Chevy Chase Village
Board of Managers

Continuance of A-6895 (Appeal of the Manager's Decision):

Appeal of the Village Manager's issuance of Building Permit #6879 (to Mr. David J. and Ms. Megan L. Rose of 5502 Grove Street) to construct a fence measuring six feet, six inches (6'-6") in height and a retaining wall measuring a maximum of three (3) feet in height abutting their rear property line.

STAFF INFORMATION REPORT

Figure 13: Alternative 2 floor drawing

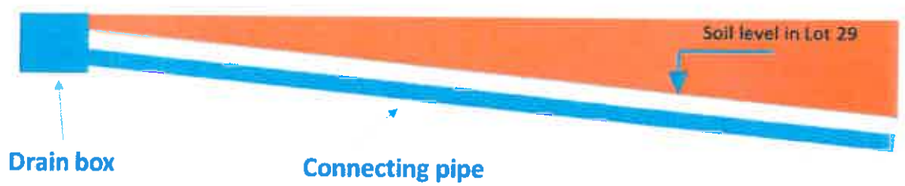
The inconvenient for the owners of Lot 29 is that a part of the pipe would have to be dug in their property. If the owner of Lot 26 does not clean properly the box or his section of the pipe, the problem would come back again. It is advised to leave a 2 feet width corridor between the wall and the fence for maintenance purposes.

The connection along the limit with Lot 30 wouldn't be possible since the height difference between Center St. and the drain box wouldn't be enough or would require a too large section for the pipe. For the proposed alternative **the minimum pipe section should be at least 5 inches** and the box size should cover the gap between the property limits and the end of the wall. The box depth, which could also include a chamber, would have to be deep enough to feed the pipe and the pipe should have an adequate slope.
